SUBDIVISION REPORT - CONCEPT/USE ON REVIEW

▶ **FILE #:** 10-SC-20-C
10-D-20-UR

▶ **SUBDIVISION:** B & B BUILDERS - DRY GAP PIKE

**10-SC-20-C / 10-D-20-UR
CONCEPT PLAN/USE ON REVIEW**

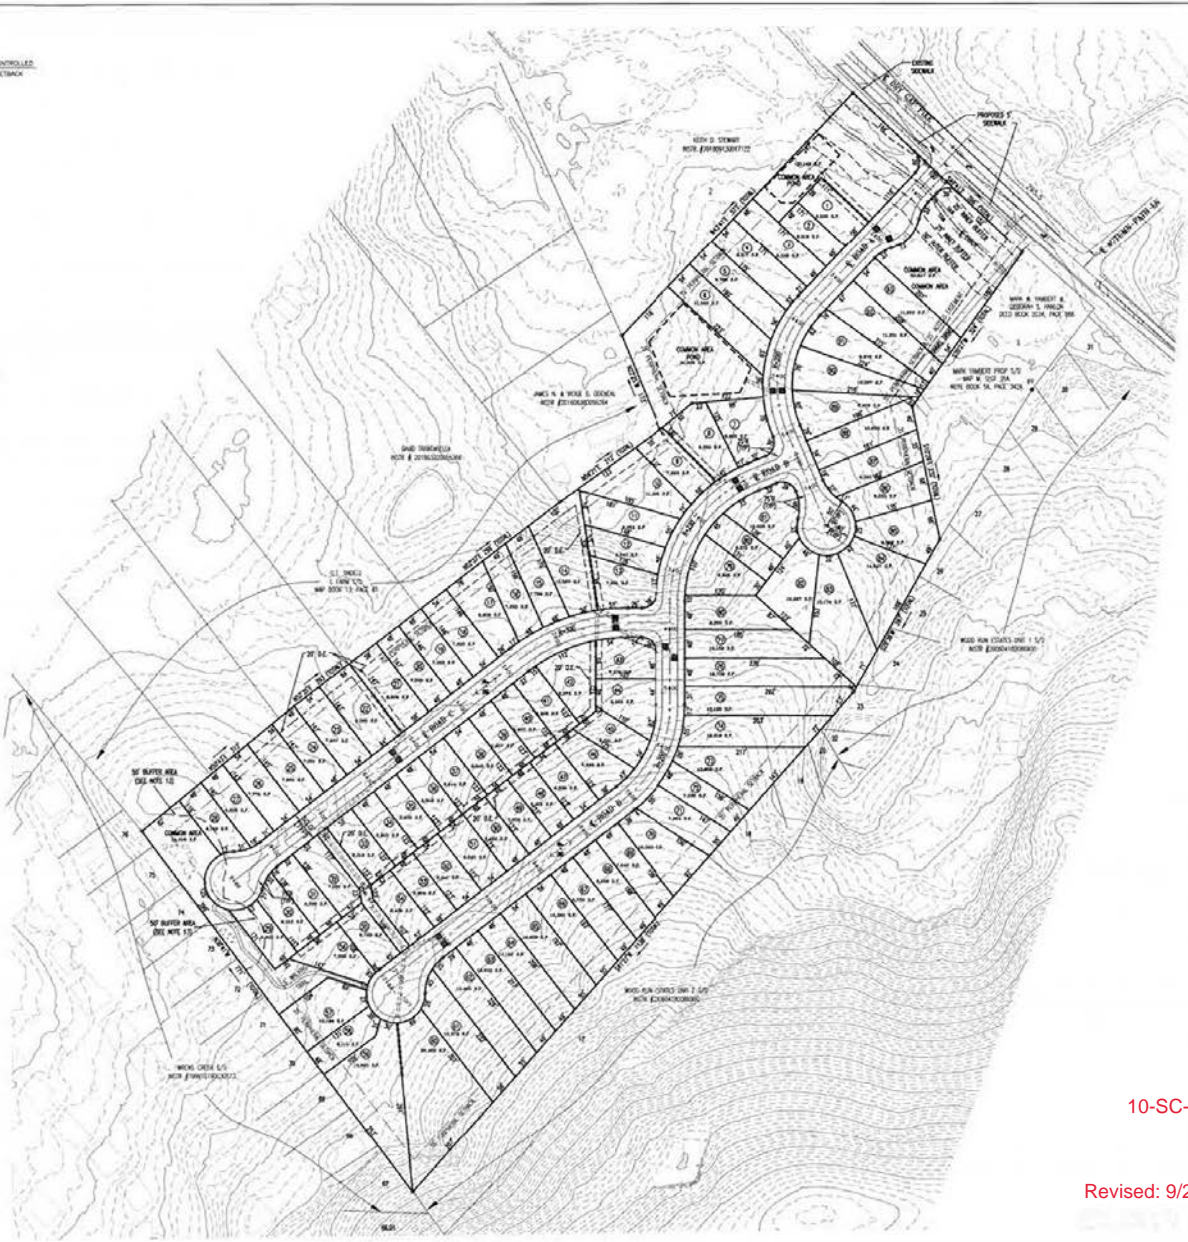
- 1) REDUCTION OF INTERSECTION SPACING ON POND GAP PIKE BETWEEN ROAD 'A' AND AUTUMN PATH LANE FROM 300 FEET TO 295.6 FEET.
- 2) REDUCTION OF THE MINIMUM CONNECTING VERTICAL CURVE K VALUE ON ROAD 'A' AT STA 2+50, FROM 25 TO 15.

- 1) REDUCTION OF MINIMUM HORIZONTAL CURVE RADIUS ON ROAD

'B' AT STA 2+50 FROM 250' TO 230'
2) REDUCTION OF MINIMUM HORIZONTAL CURVE RADIUS ON ROAD
'B' AT STA 6+00 FROM 250' TO 200'

- 1) INCREASE MINIMUM INTERSECTION GRADE AT ROAD 'A', STA
0+13 TO STA 2+50, FROM 1% TO 2%**
- 2) INCREASE MINIMUM INTERSECTION GRADE AT ROAD 'B', STA
0+13 TO STA 2+25, FROM 1% TO 3%**
- 3) INCREASE MINIMUM INTERSECTION GRADE AT ROAD 'C', STA
0+13 TO STA 1+00, FROM 1% TO 2%**

6. Revising Road 'A' at the Dry Gap Pike intersection to work with the proposed profile and pavement edge of the pending Dry Gap Pike road widening project.

7. Revising the grade of Road 'A' at the Dry Gap Pike intersection to meet the crosswalk requirements of ADA and the Knox County Department of Engineering and Public Works.

- **APPROVE variance 1-2 and alternate design standard 1-2 based on the recommendations of the Knox County Department of Engineering and Public Works and because the site conditions restrict compliance with the Subdivision Regulations and the proposed variance will not create a traffic hazard.**

APPROVE the Concept Plan subject to 11 conditions.

4. Providing an access easement, as shown on the Concept Plan, for the existing driveway on the adjacent property (parcel 047-24102) that crosses the subject property through the common area south of Road 'A' along Dry Gap Pike and lots 88-93.

Dry Gap Pike at Road "A":

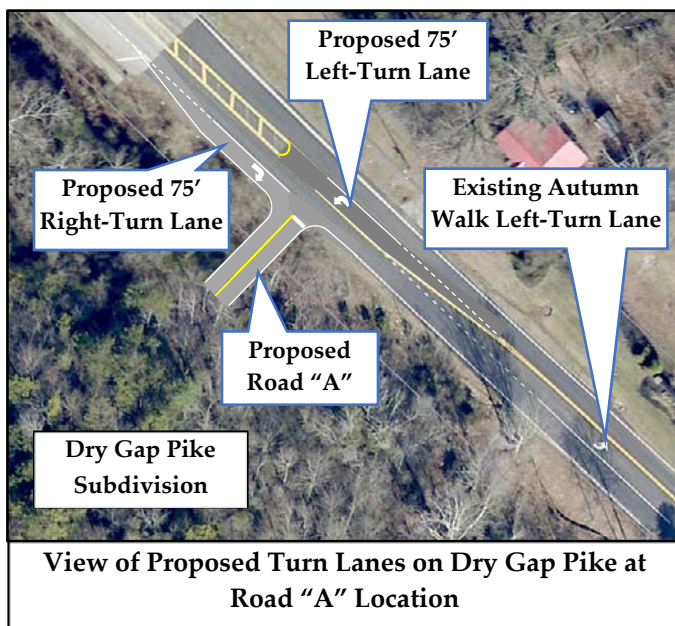
- 1a) The capacity calculation results shown in Table 5 indicate that northbound left-turns from a separate left-turn lane on Dry Gap Pike into the development at Road "A" should operate very well during the AM and PM peak periods in the year 2025. The level of service for exiting vehicles at Road "A" with a single lane will operate adequately but at a reduced level. For the AM and PM peak periods, eastbound exiting vehicles will operate at LOS C and D, respectively. These lower levels of service are directly related to large numbers of thru vehicles on Dry Gap Pike in the peak periods that conflict with these future exiting turning movements. However, it is possible the gaps in traffic on Dry Gap Pike due to the influence of the signalized intersection to the north at East Beaver Creek Drive/Cunningham Road may be more significant than can be modeled.

- 1b) As discussed earlier, it is recommended that the intersection of Dry Gap Pike at Road "A" have an exclusive southbound right-turn lane and northbound left-turn lane based on the projected 2025 AM and PM peak hour volumes. These lanes should be installed by 2025 or before the subdivision is completely constructed.

Typically, determining the length of a right-turn lane would be made by calculating the stopping sight distance based on the observed operating speed. Based on A Policy on Geometric Design of Highway and Streets by the American Association of Highway Transportation Officials (AASHTO), 325 feet is recommended for vehicles to decelerate and stop from a posted speed limit of 40-mph. However, this recommended length is based on vehicles coming to a complete stop, and the southbound right-turning vehicles coming off Dry Gap Pike onto Road "A" will not completely stop. A 75-foot right-turn length is a reasonable length consistent with the Autumn Walk Subdivision right-turn lane located across Dry Gap Pike. A recommended taper length of 120 feet (10:1) with 75 feet of storage is based on the available distance between the proposed subdivision entrance location and the adjacent property line to the north. The right-turn lane should

The northbound left-turn lane is also recommended to be 75 feet in length, and the taper should match the existing taper provided for the left-turn lane for the Autumn Walk Subdivision. Due to horizontal space constraints, the proposed left-turn lane for the Dry Gap Pike Subdivision will need to be constructed back-to-back to the existing southbound left-turn lane on Dry Gap Pike.

Constructing a left-turn lane for the Dry Gap Pike Subdivision will also require Dry Gap Pike to be widened slightly since the existing center transverse pavement marking area is only approximately 8 feet in width at the proposed entrance location. The left-turn lane will require the appropriate pavement marking symbols and marked at the proper spacing.

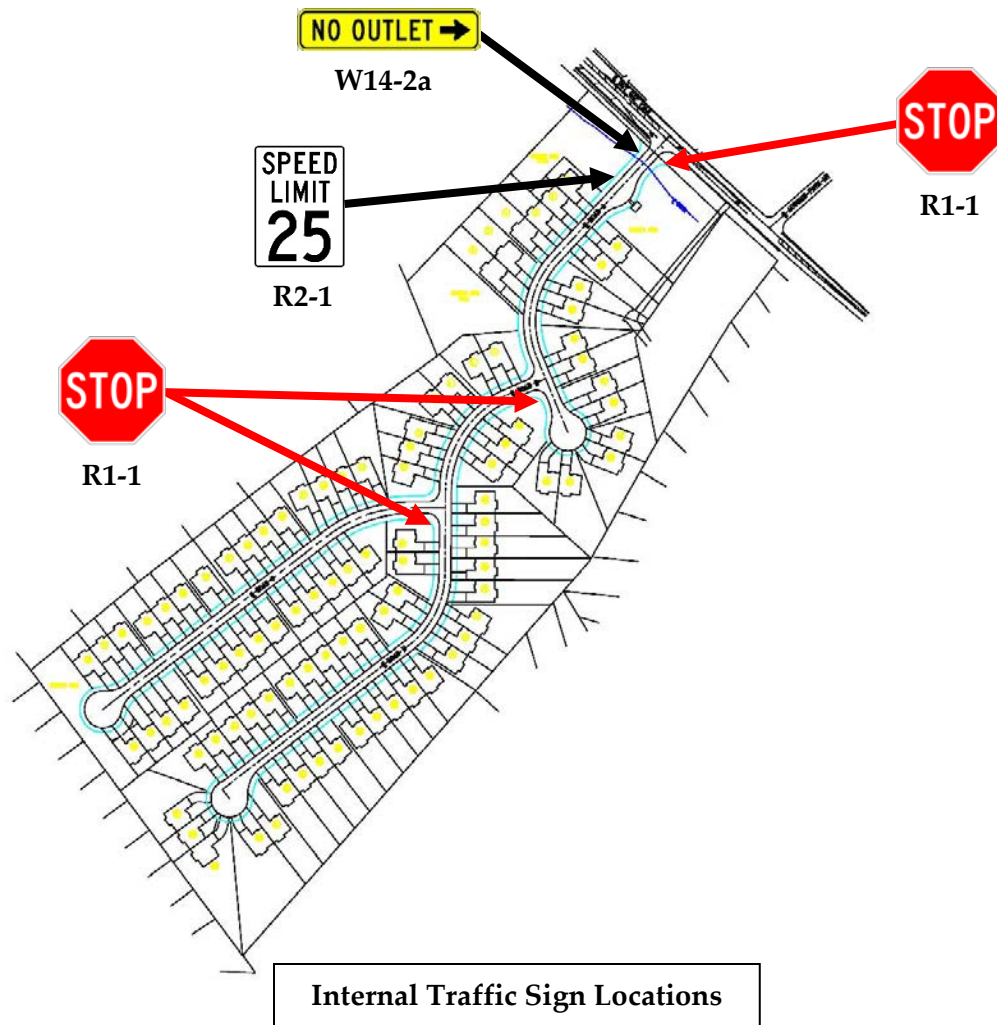
- 1e) It is recommended that the Road "A" entrance approach at Dry Gap Pike be designed and constructed with a 24" white stop bar and a Stop Sign (R1-1). The stop bar should be applied at a minimum of 4 feet away from the edge of Dry Gap Pike and should be placed at the desired stopping point that provides the maximum sight distance.

Dry Gap Pike Subdivision Internal Roads: The current concept plan shows three new streets being constructed within the development, as shown in Figure 3.

- 2a) It is recommended that a “No Outlet” Sign (W14-2a) be posted near the front of the subdivision on Road “A”. This sign can be posted below the street name sign. A 25-mph Speed Limit Sign (R2-1) should also be posted at the beginning of Road “A”.

- 2b) Stop Signs (R1-1) with 24” white stop bars and other traffic signage should be installed at the locations, as shown below:
